South Whidbey Aquatic Center

Addendum # 3

June 20, 2025

To All Bidders: Attention is called to the following items effective June 20, 2025, which shall be added to, deleted from, or changed from the BID DOCUMENTS dated June 2, 2025, thereby incorporating the addendum as part of the CONTRACT DOCUMENTS.

1 TOP OF SKYLIGHT
3" = 1'-0"

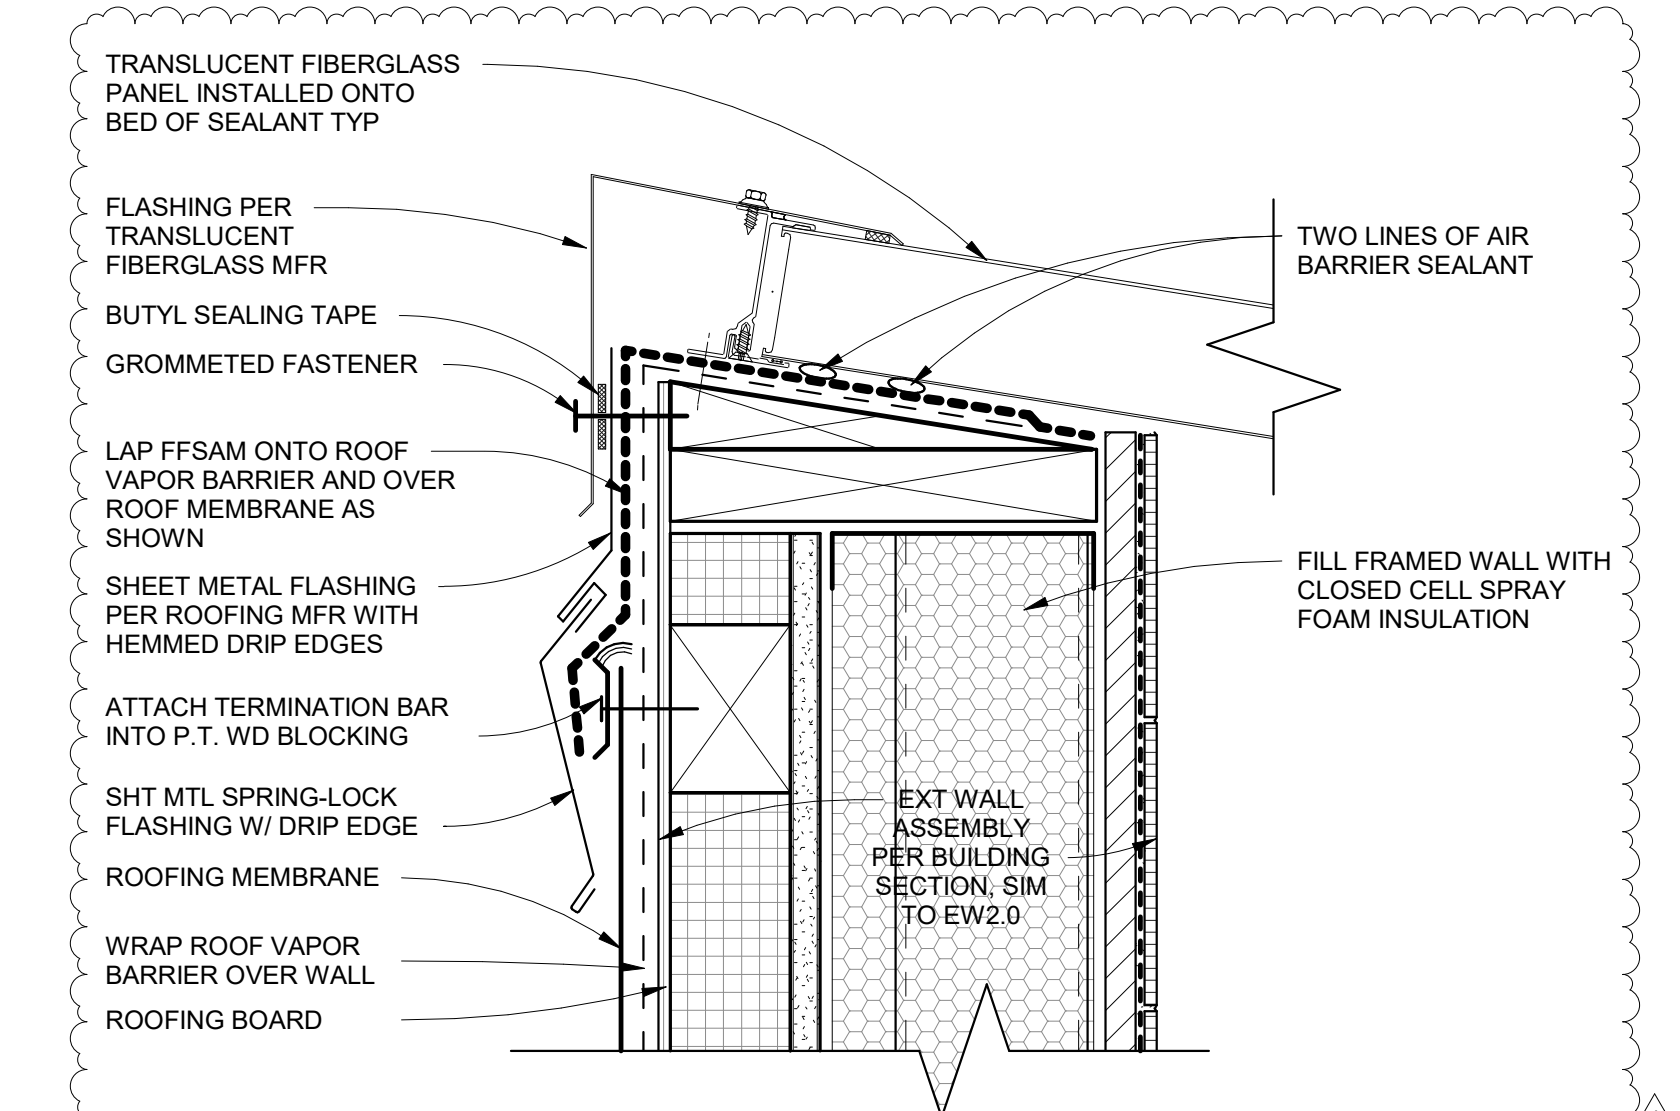
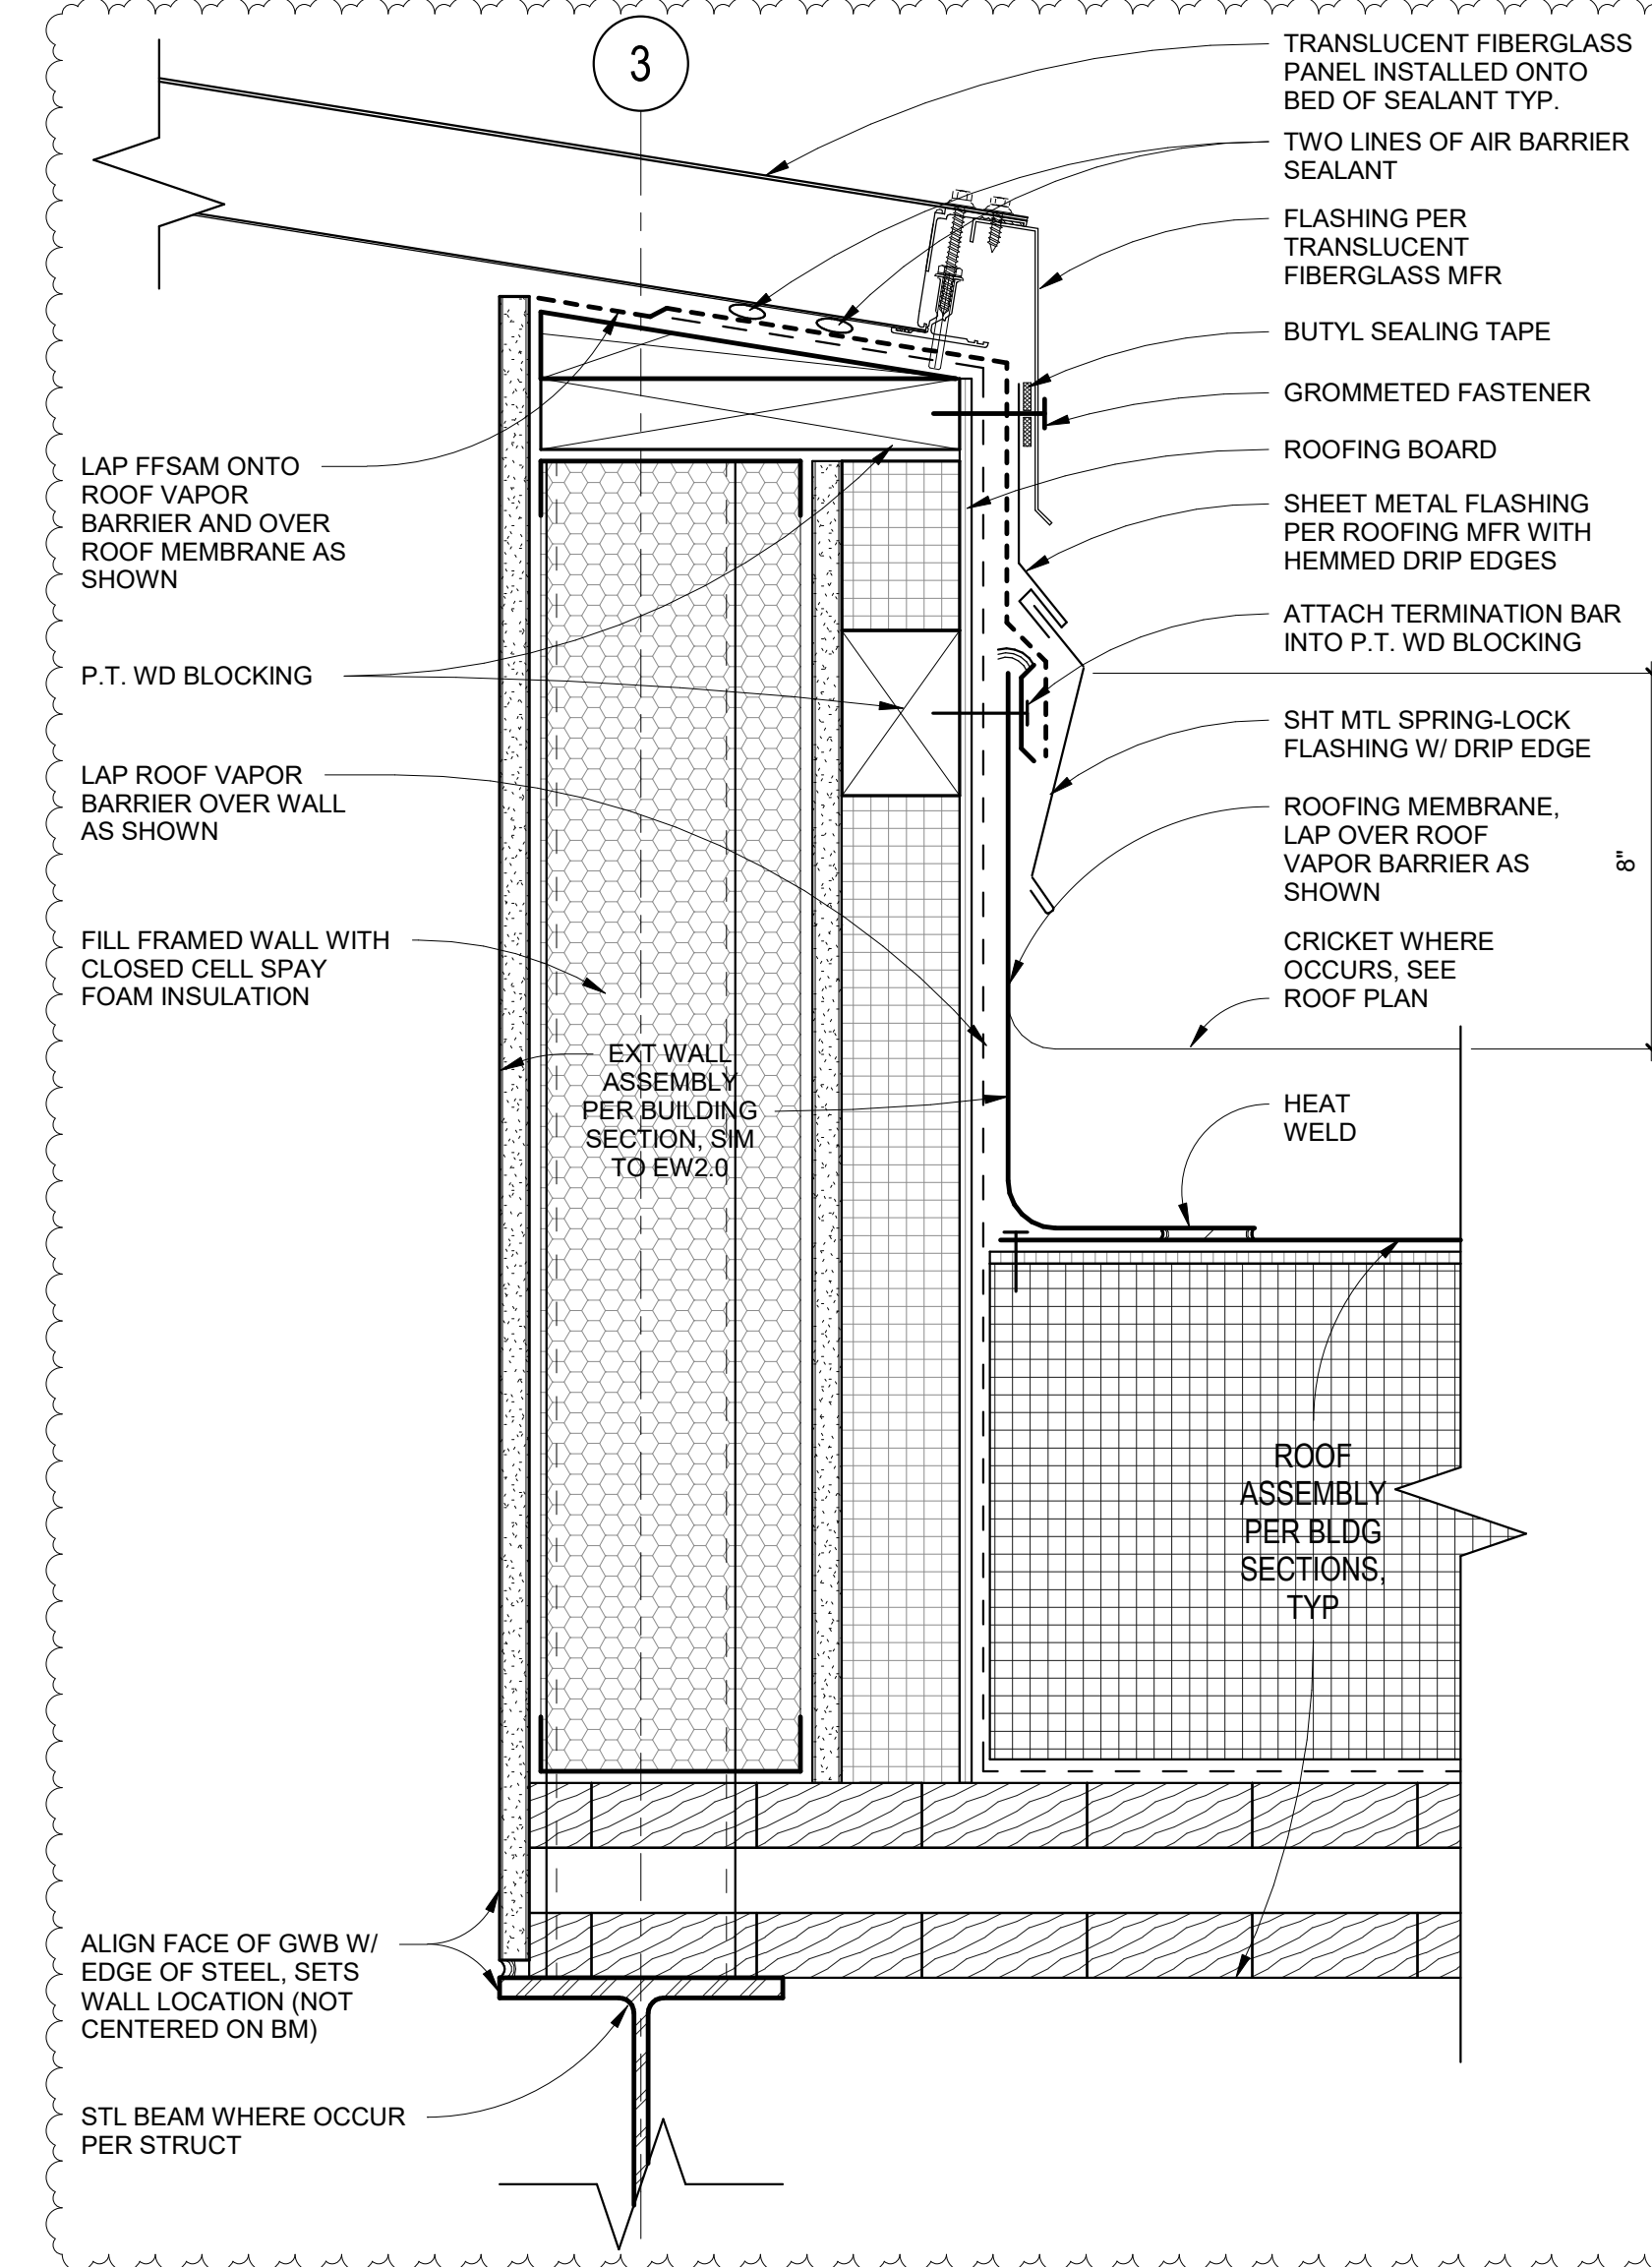
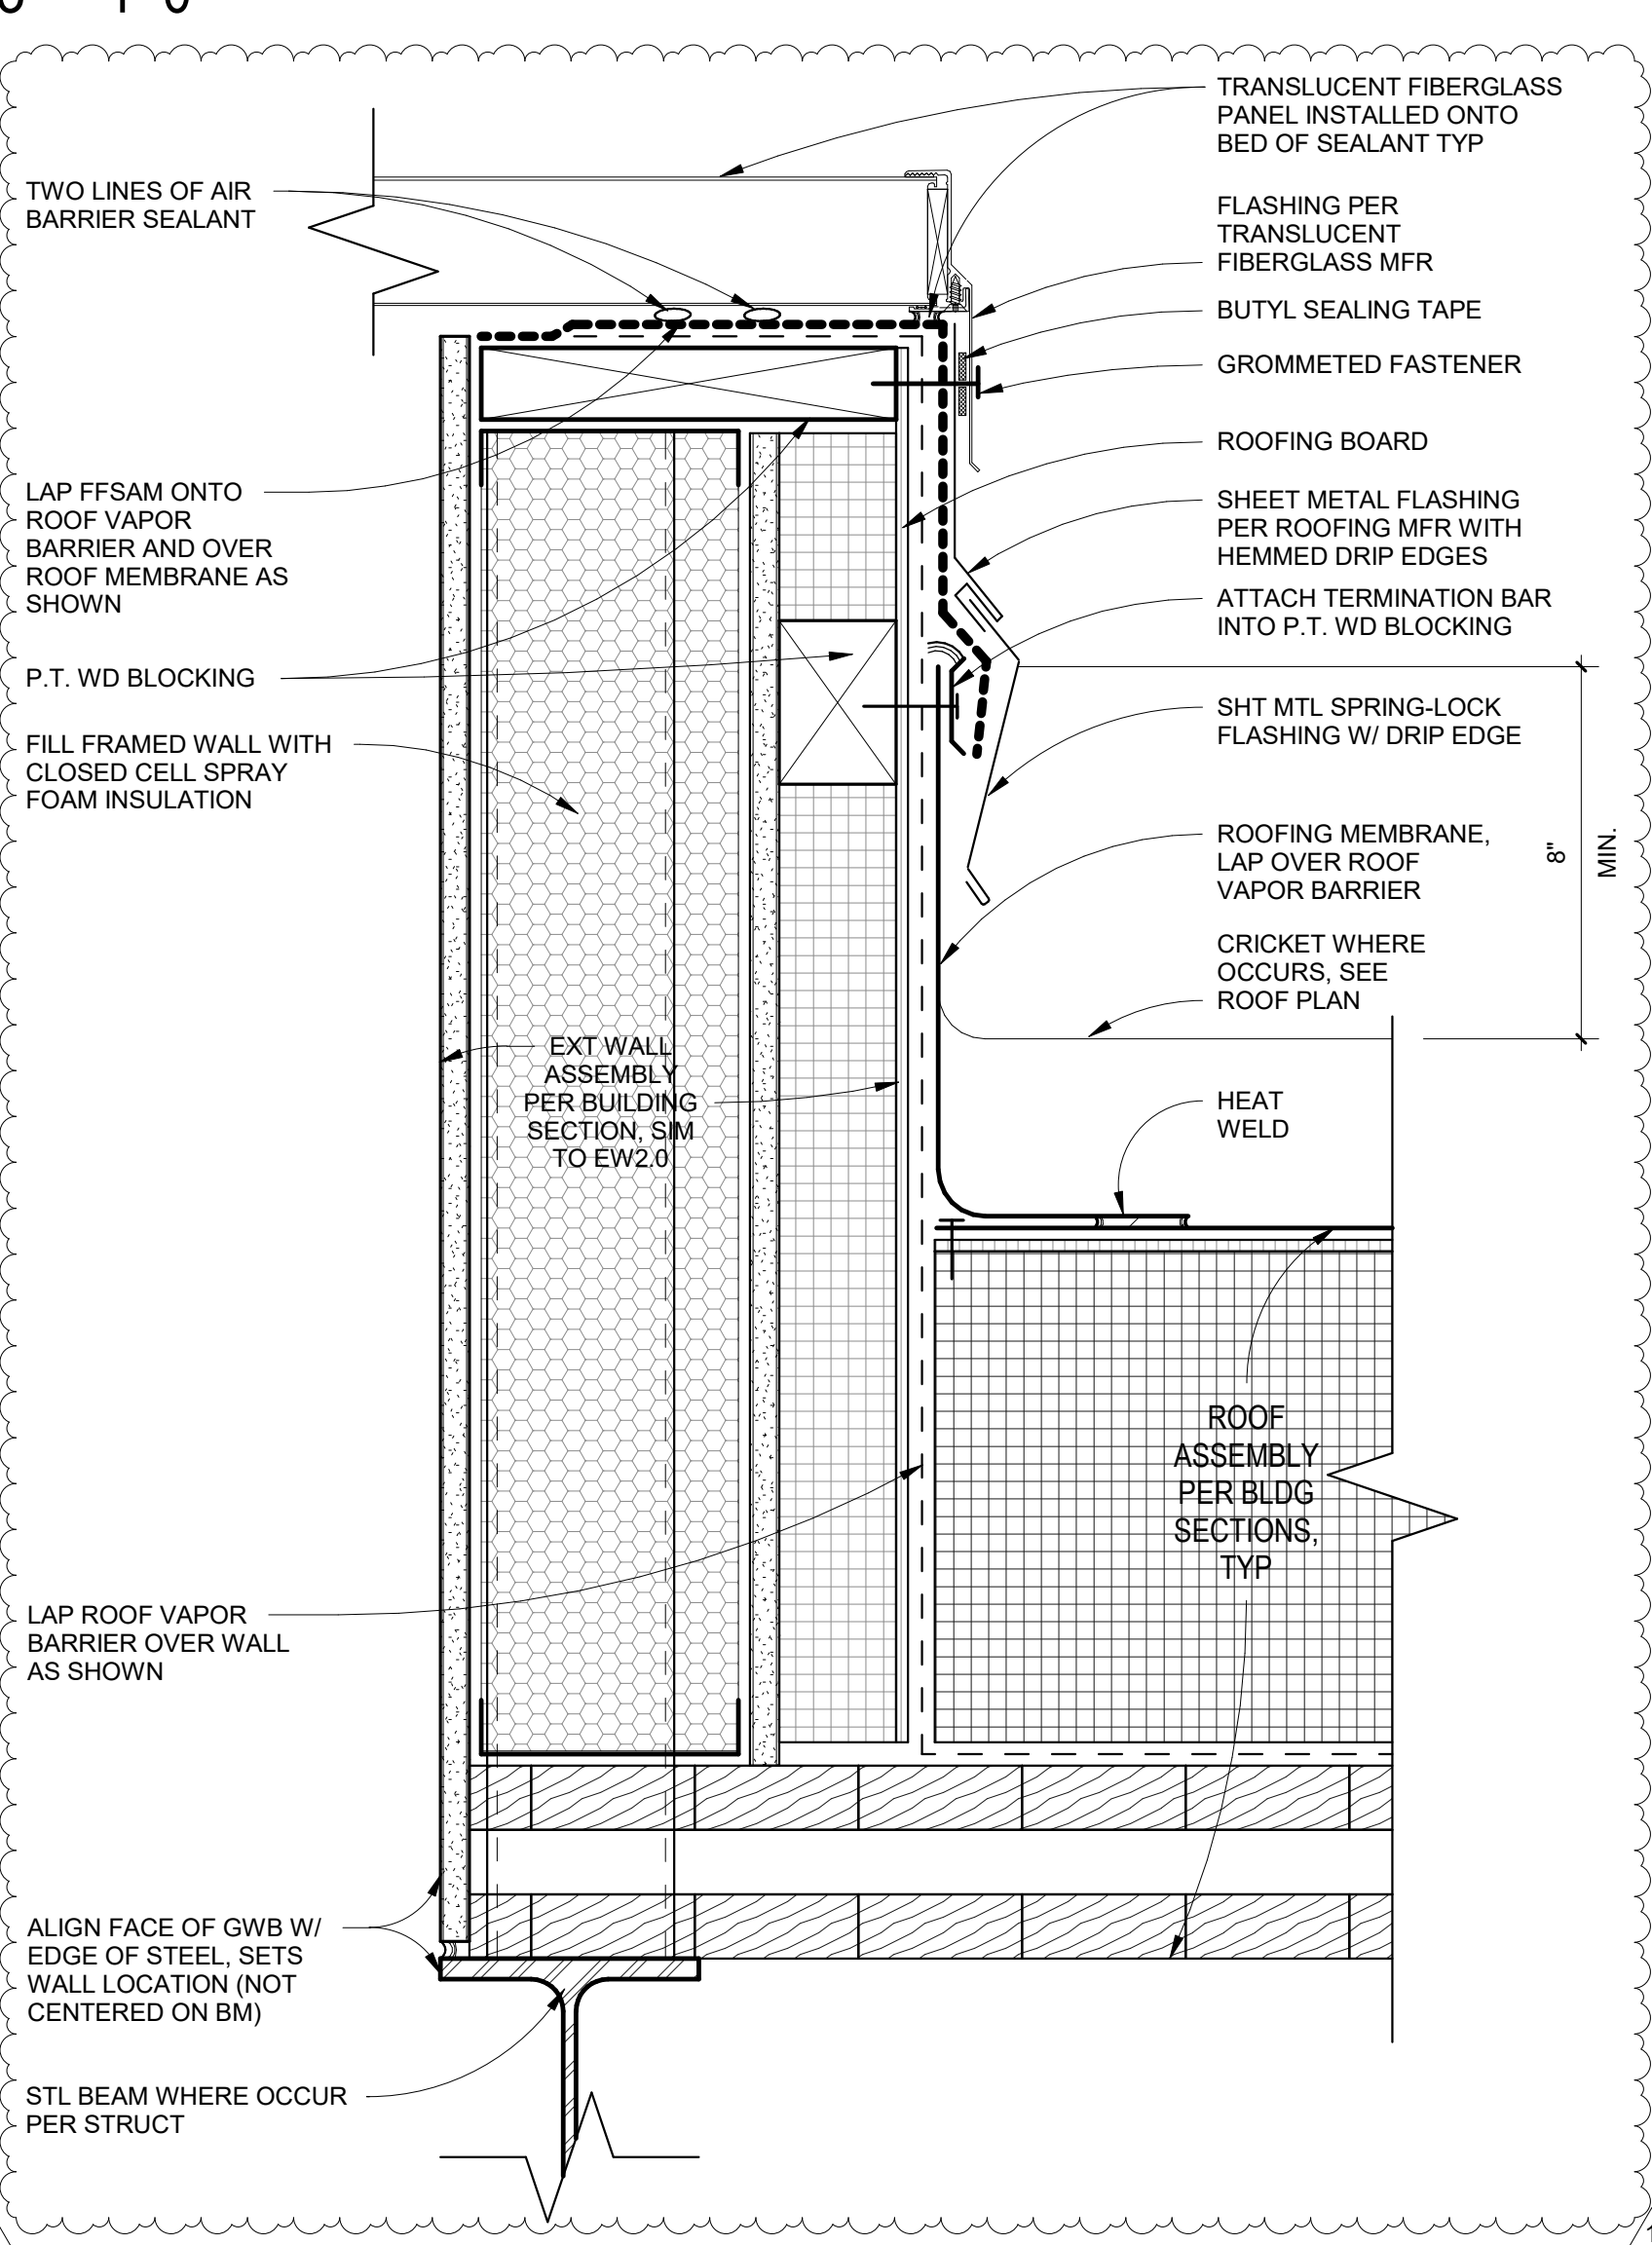
- iv. **REPLACE** – Sheet A8.5 in its entirety with the attached revised sheet A8.5.
 - 1. Updates to details 1, 2, and 5.
